## **ADDENDUM NO: 001**

**PROJECT NAME: ARLINGTON GATEWAY MONUMENT**

**PROJECT NO.: 1256.18**

**DATE: 07/15/2022**

## Project and Construction Layout Plan

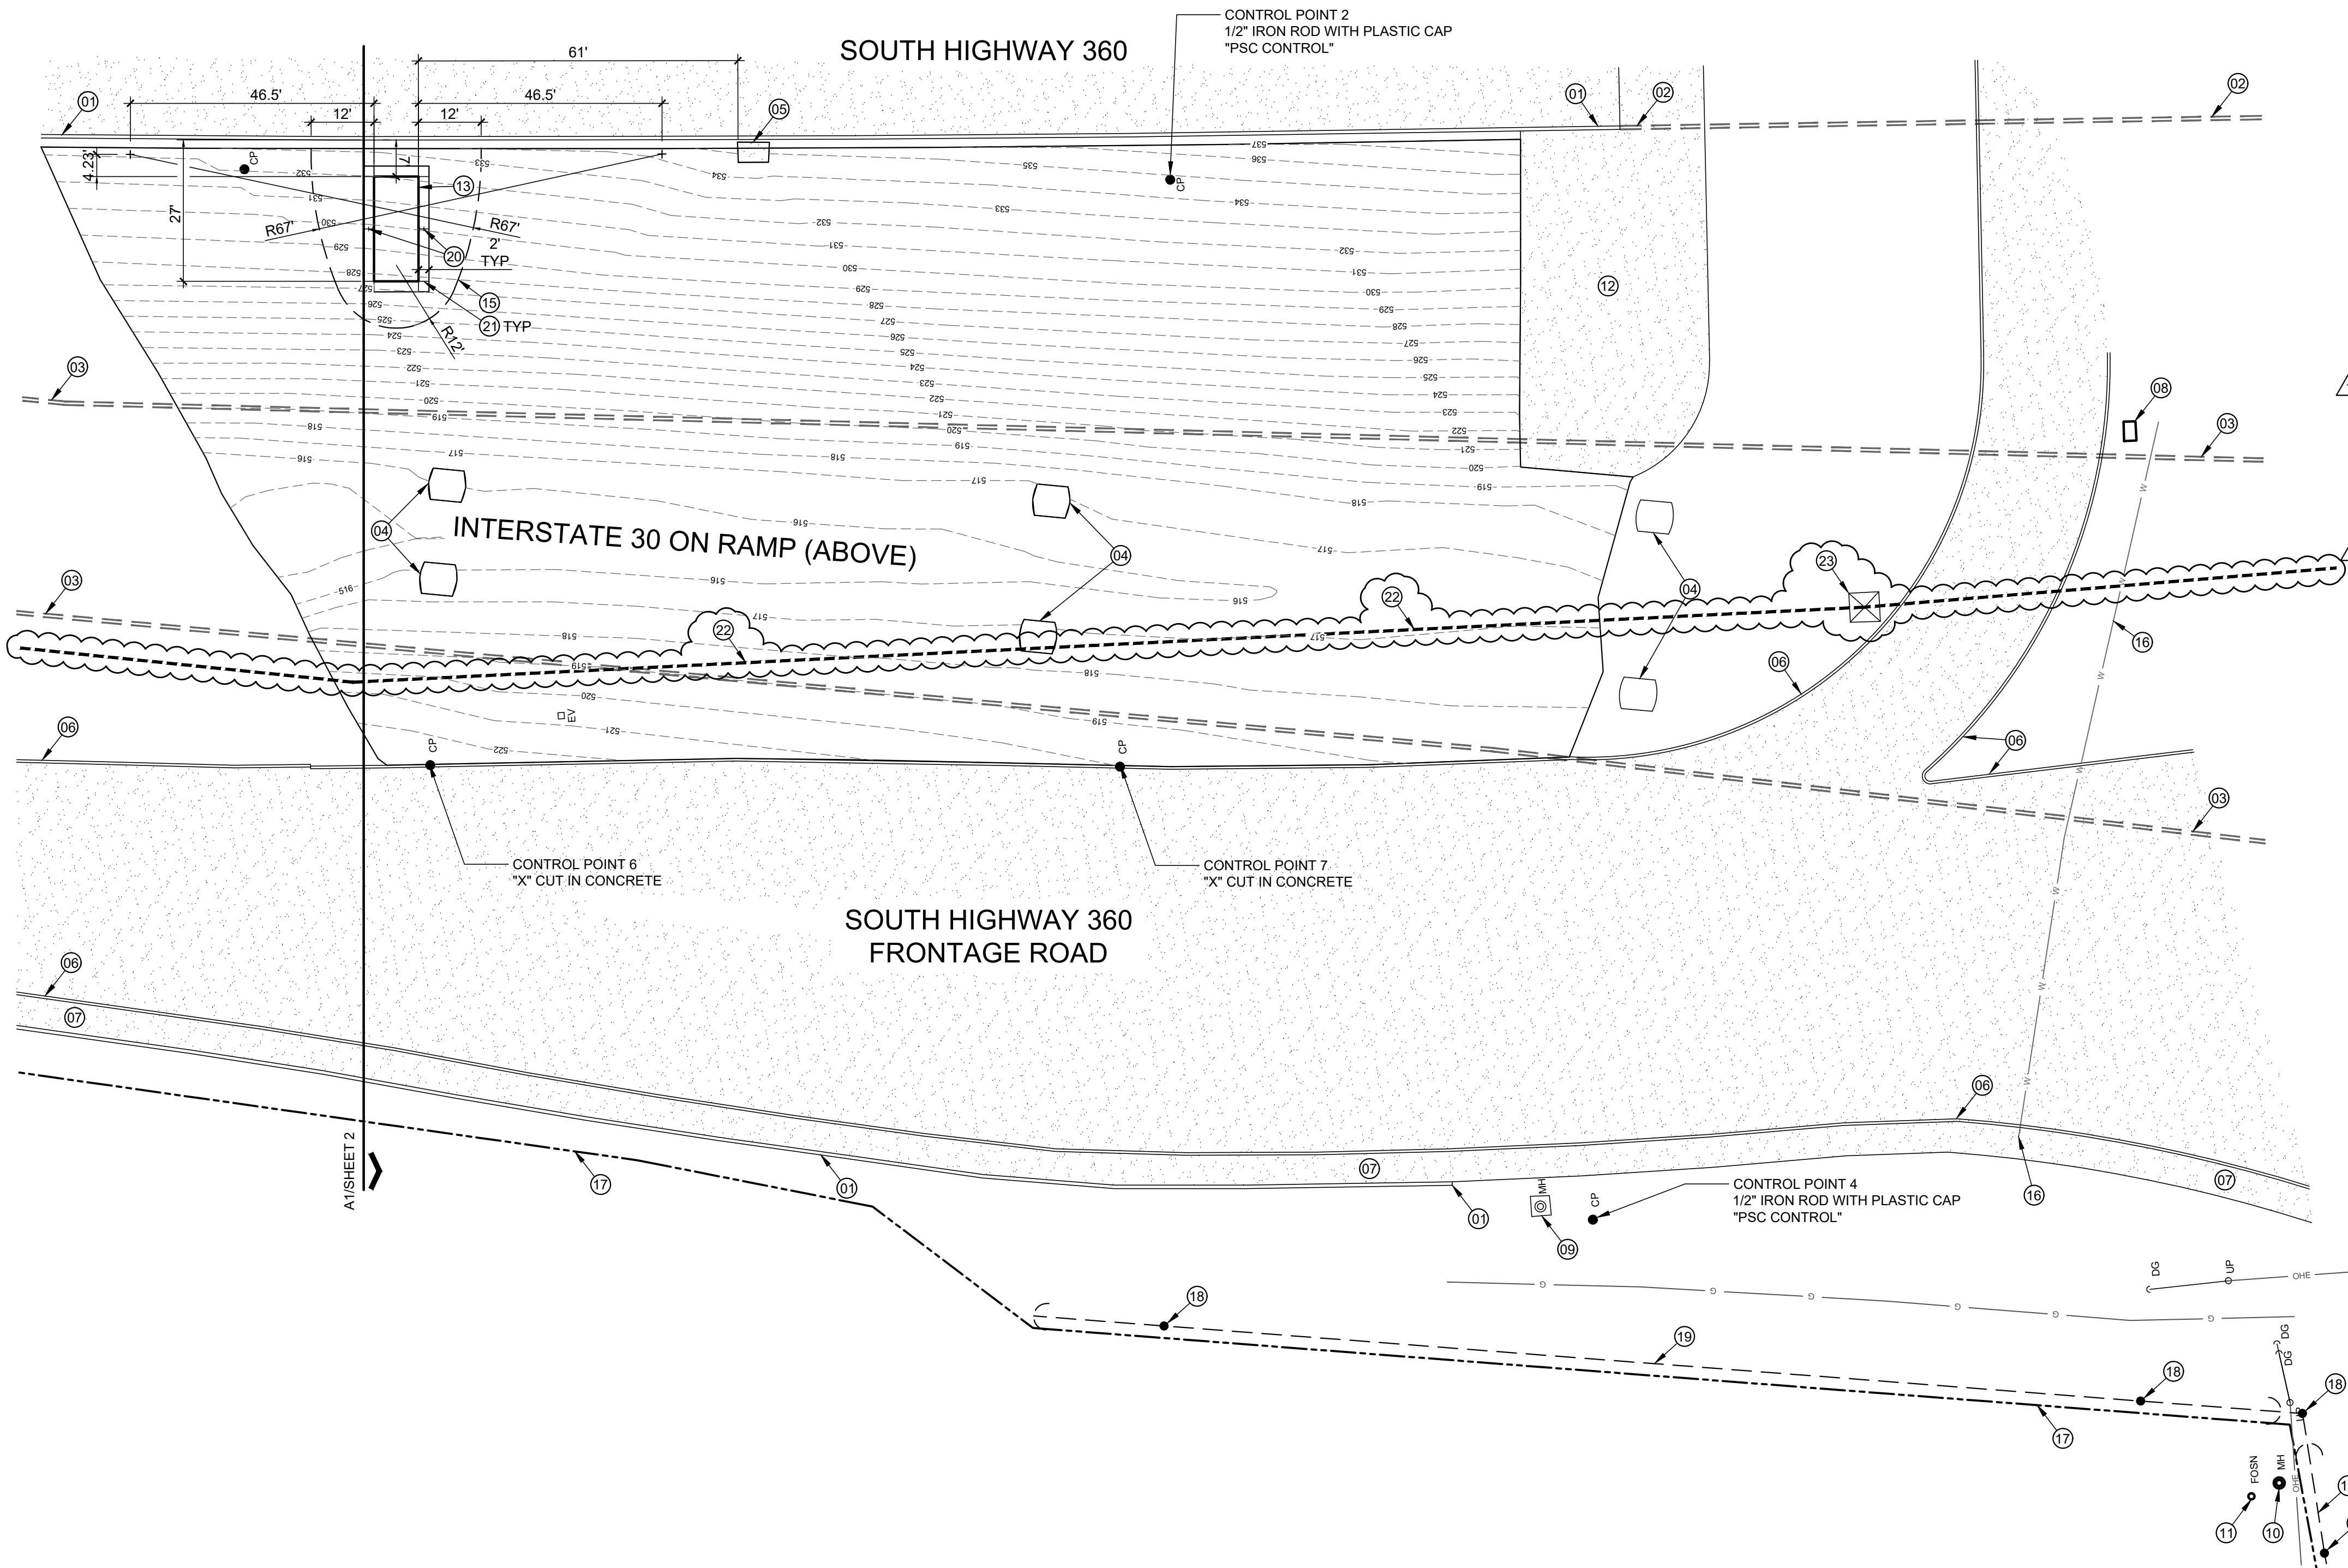
1. Sheet 1 – PROJECT AND CONSTRUCTION LAYOUT PLAN
  - a. Refer to revised sheet as attached to this addendum.
    - 1) Approximate TXDOT Fiber location added to plans per IH 30 TMS SYSTEM LAYOUT – dated 10/30/15.

- 2) Keynote 22 added – “APPROXIMATE LOCATION OF TXDOT FIBER. CONTRACTOR TO FIELD VERIFY LOCATION AND DEPTH PRIOR TO CONSTRUCTION”
    - 3) Keynote 23 added – “APPROXIMATE LOCATION OF TXDOT AS GROUND BOX”

## Existing Utilities, Erosion Control, & Grading Plan

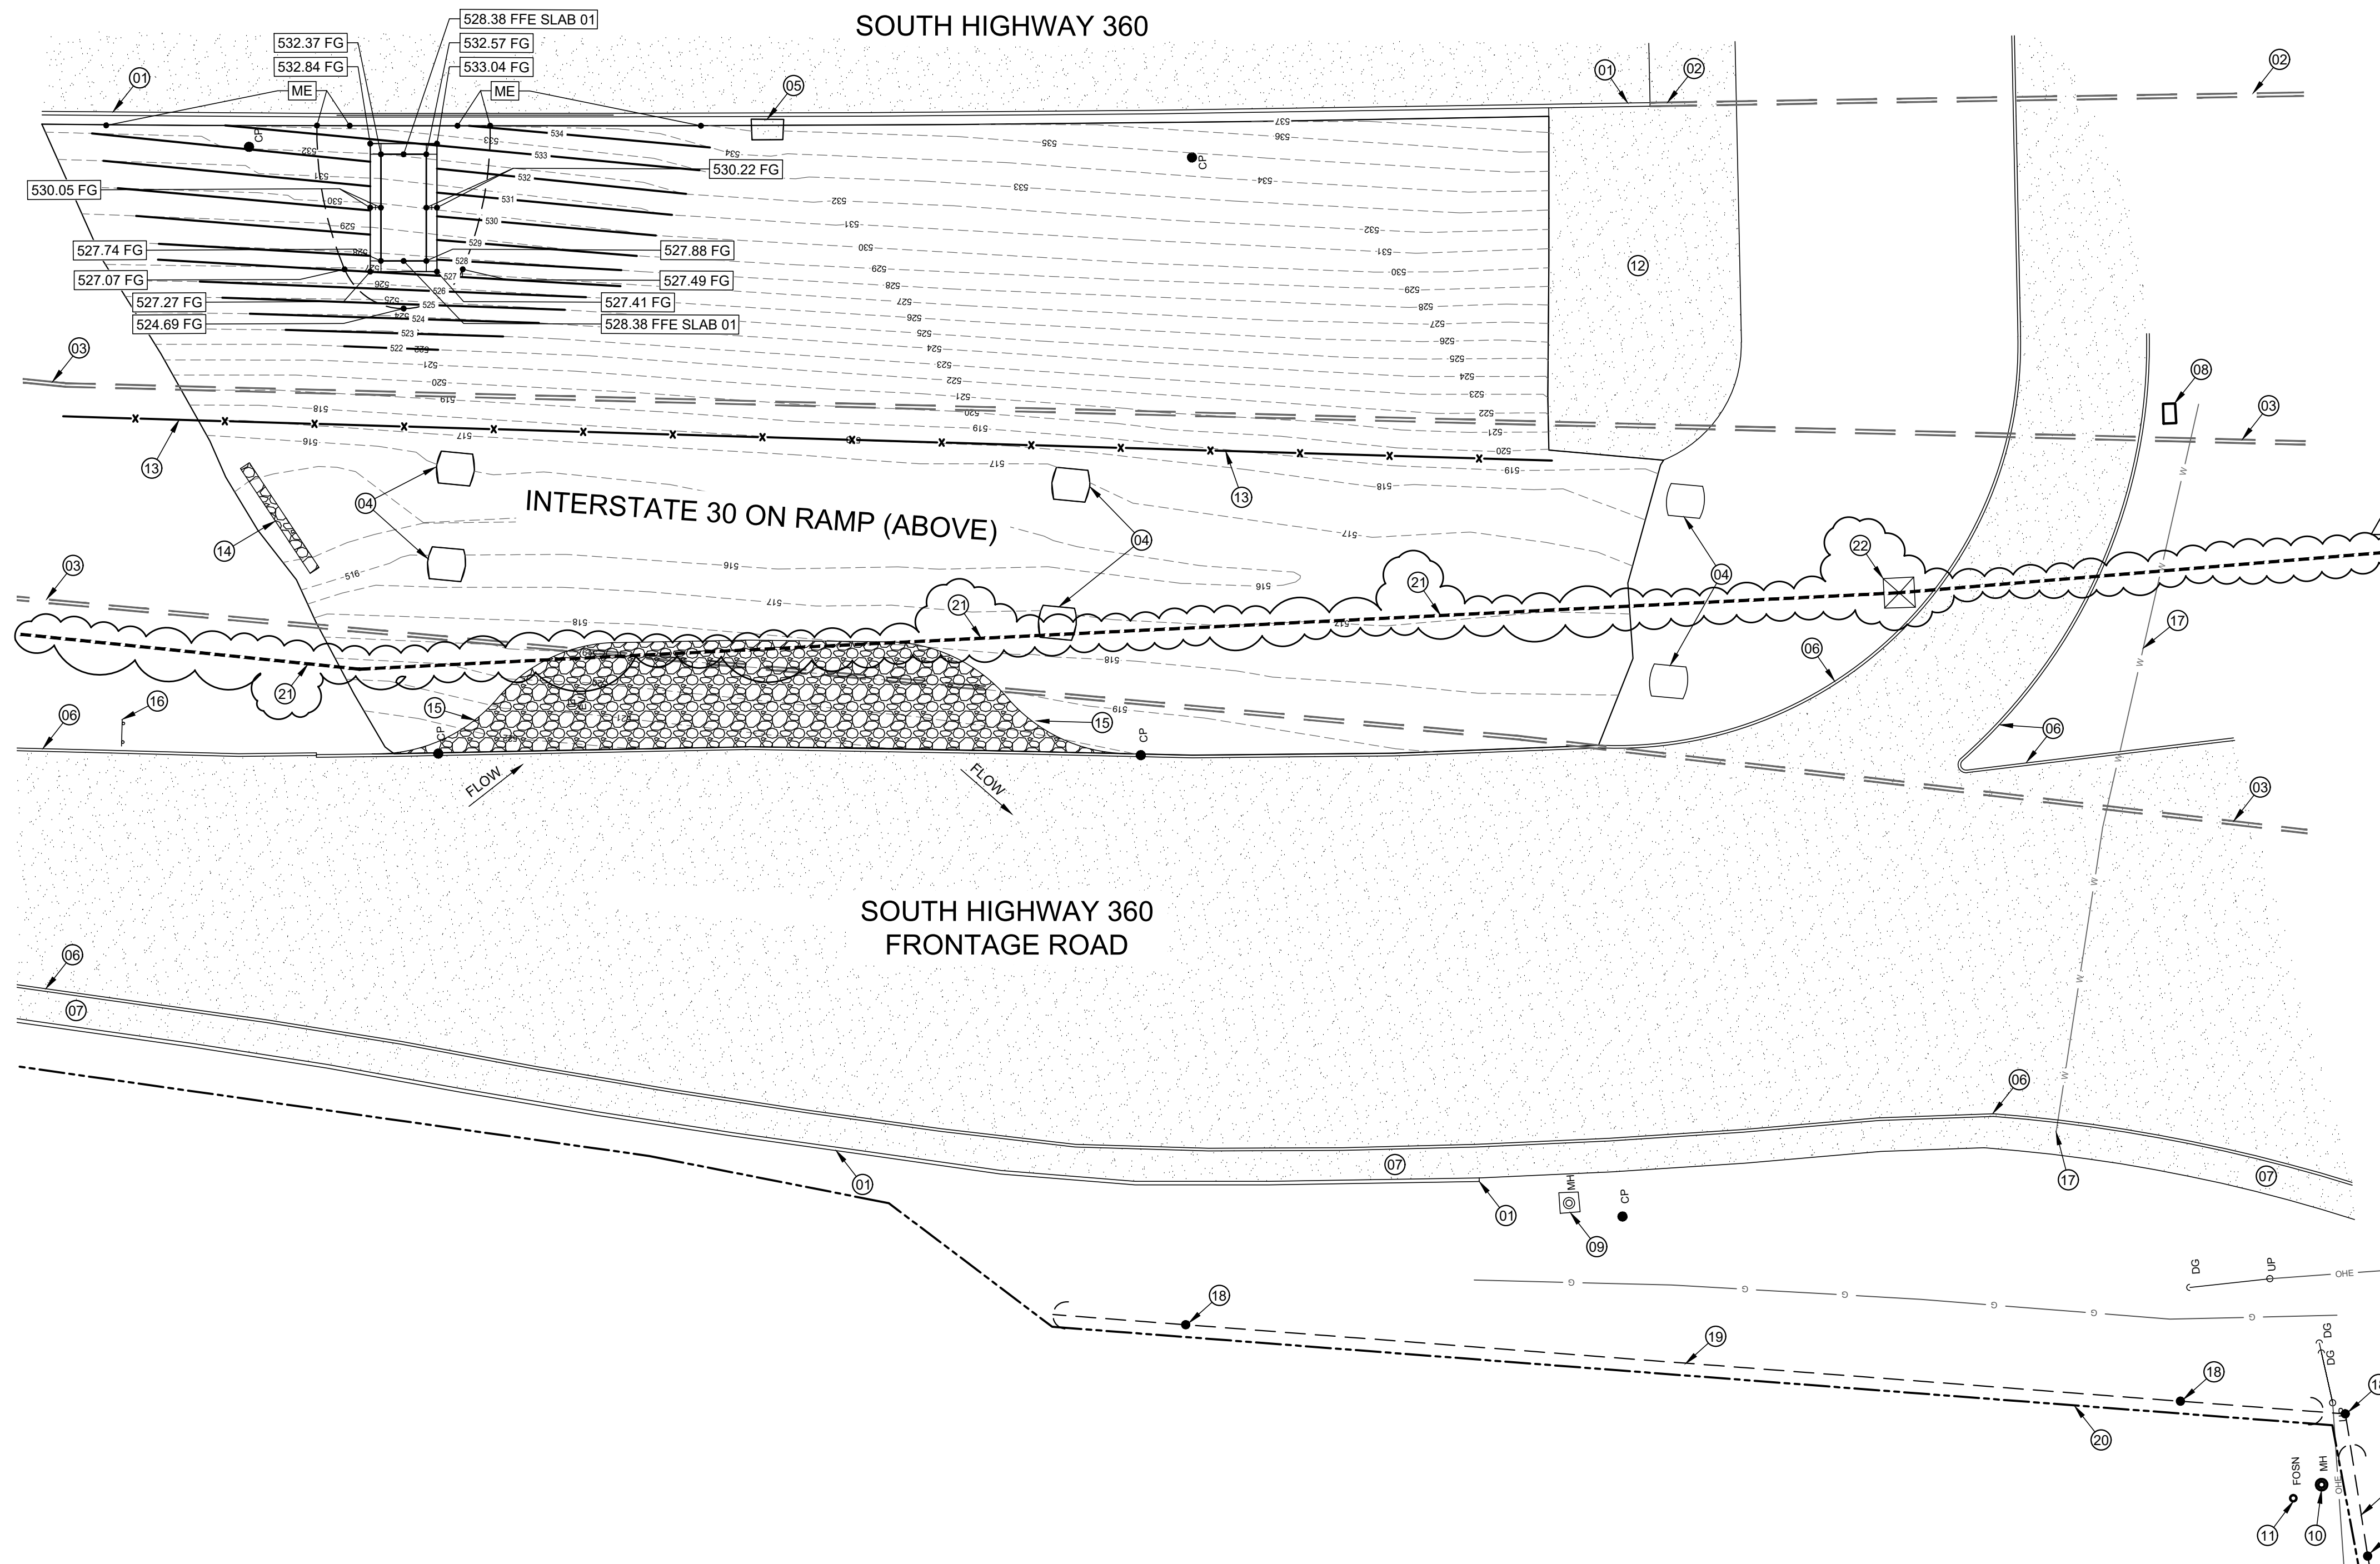
2. Sheet 4 – EXISTING UTILITIES, EROSION CONTROL, & GRADING PLAN
  - a. Refer to revised sheet as attached to this addendum.
    - 1) Approximate TXDOT Fiber location added to plans per IH 30 TMS SYSTEM LAYOUT – dated 10/30/15.

- 2) Keynote 21 added – “APPROXIMATE LOCATION OF TXDOT FIBER. CONTRACTOR TO FIELD VERIFY LOCATION AND DEPTH PRIOR TO CONSTRUCTION”
    - 3) Keynote 22 added – “APPROXIMATE LOCATION OF TXDOT AS GROUND BOX”

**Planting Plan**

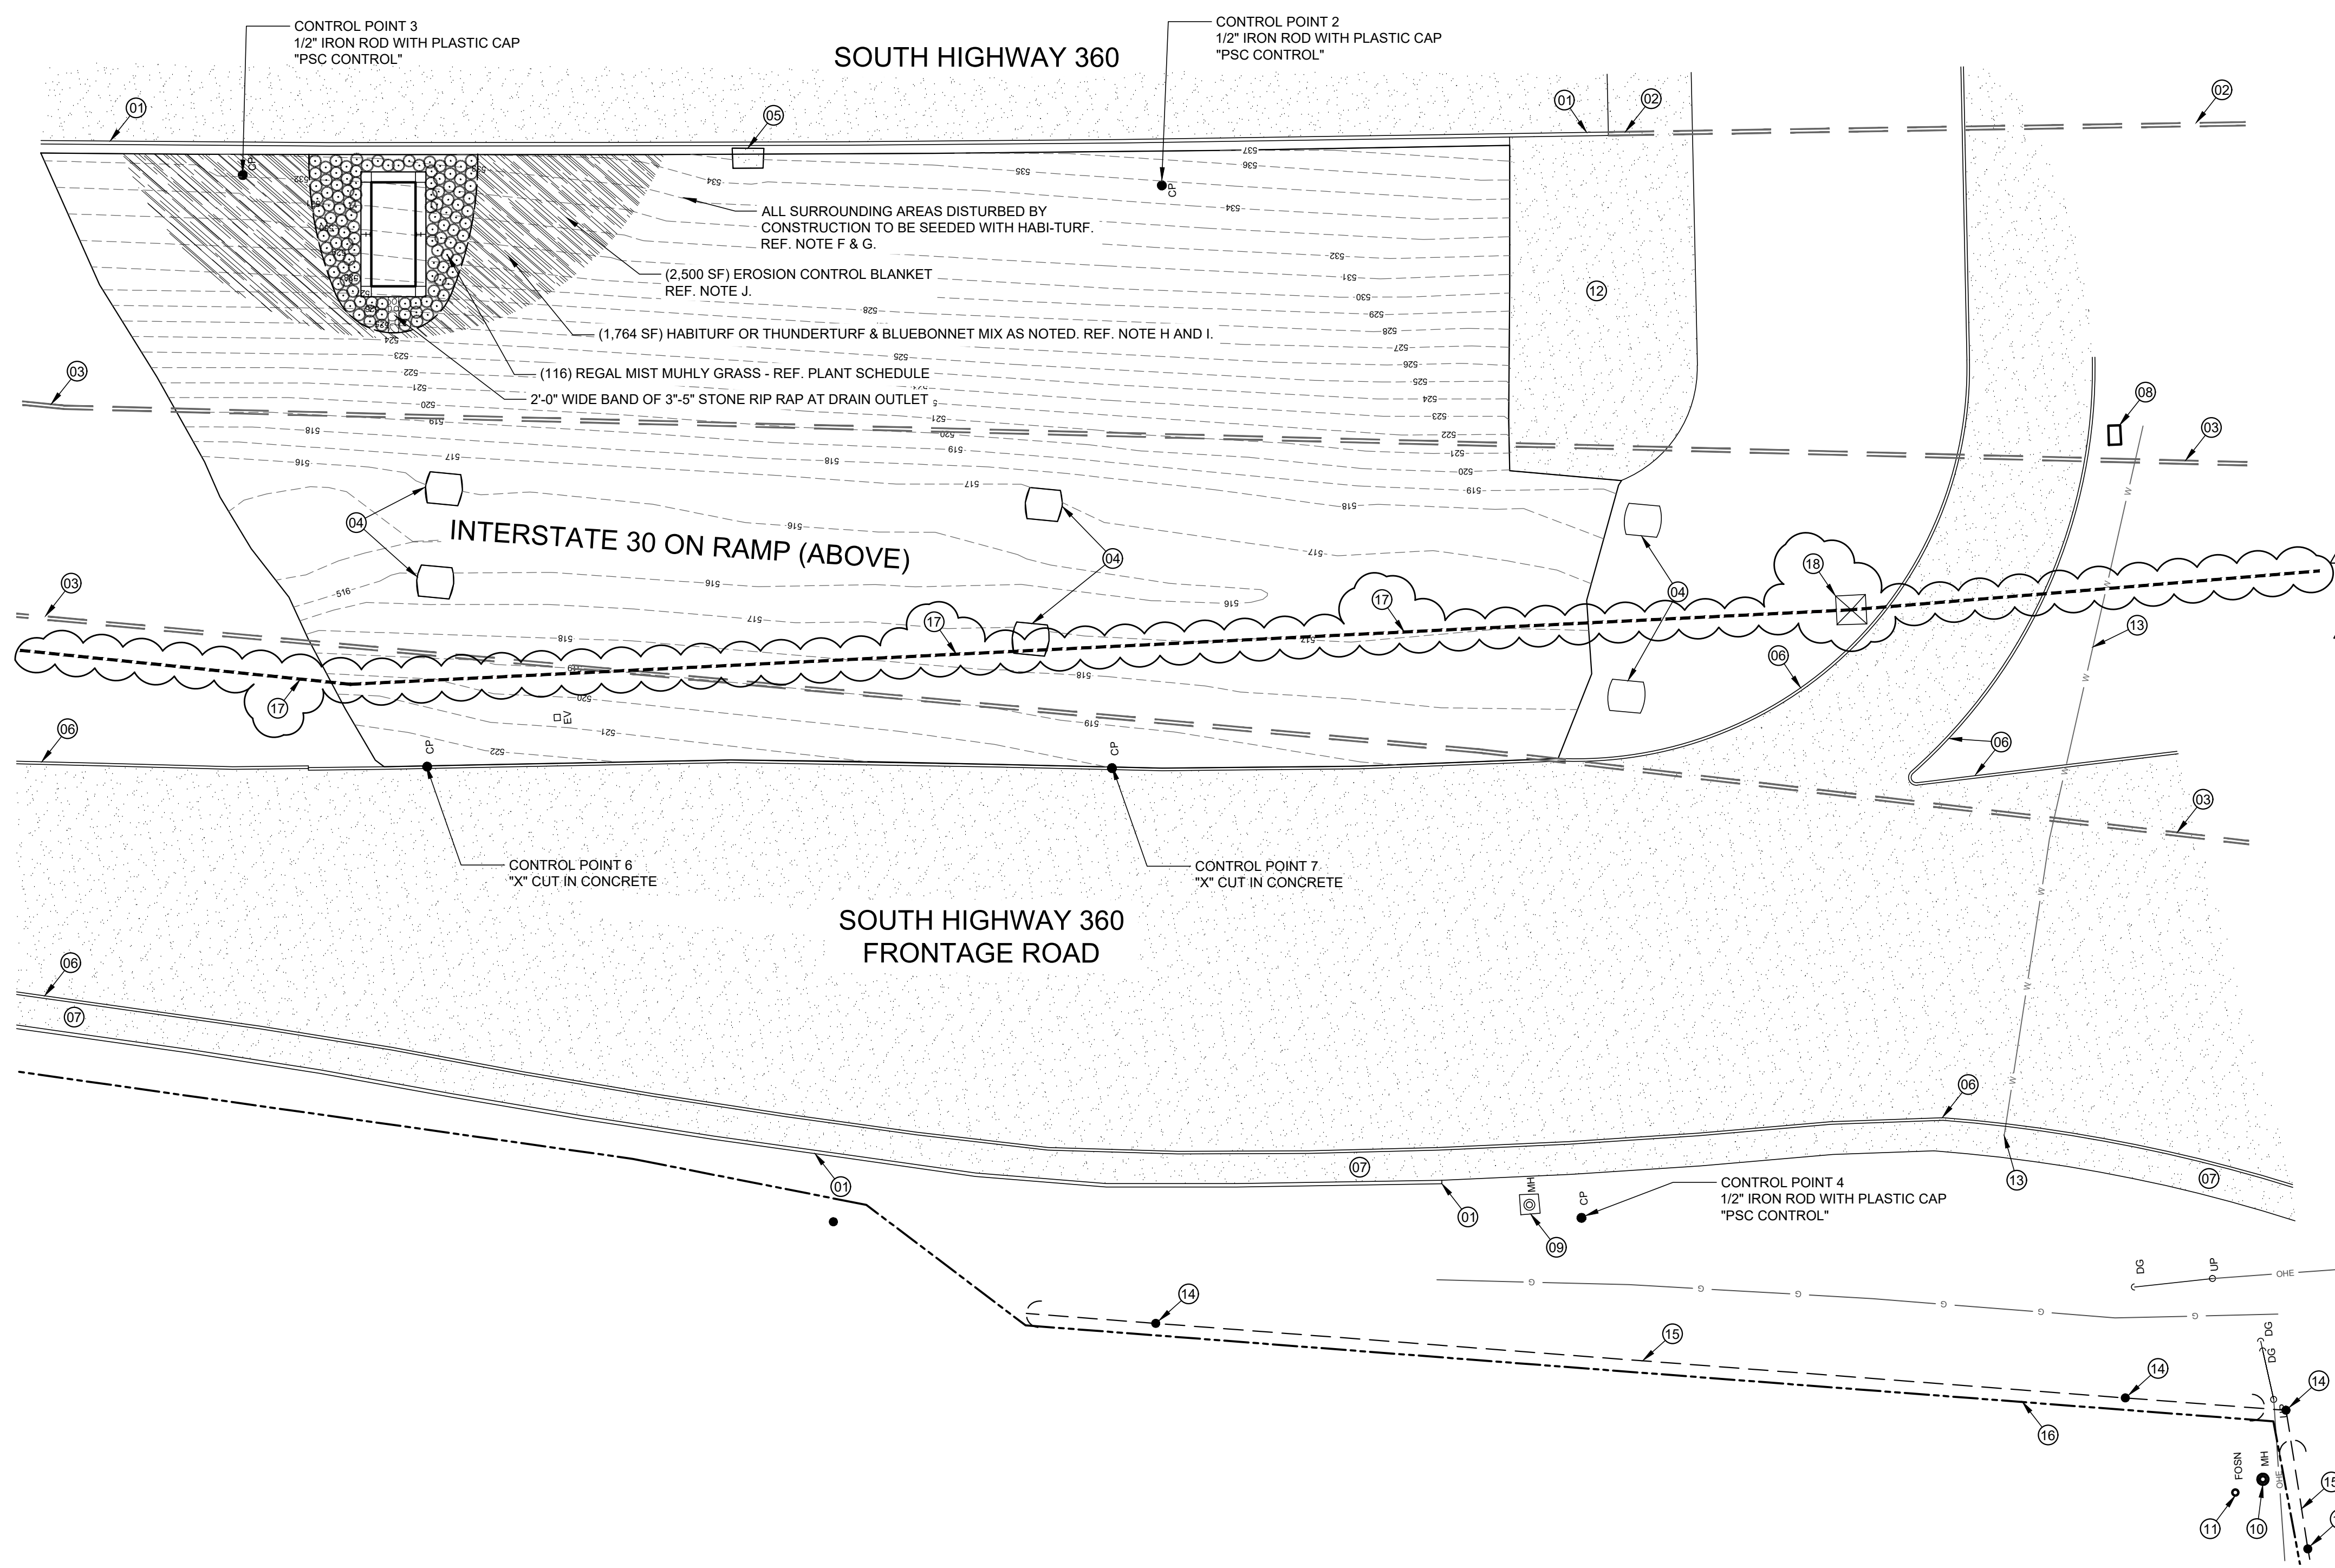
3. Sheet 5 – PLANTING PLAN
  - a. Refer to revised sheet as attached to this addendum.
    - 1) Approximate TXDOT Fiber location added to plans per IH 30 TMS SYSTEM LAYOUT – dated 10/30/15.

- 2) Keynote 17 added – “APPROXIMATE LOCATION OF TXDOT FIBER. CONTRACTOR TO FIELD VERIFY LOCATION AND DEPTH PRIOR TO CONSTRUCTION”
    - 3) Keynote 18 added – “APPROXIMATE LOCATION OF TXDOT AS GROUND BOX”
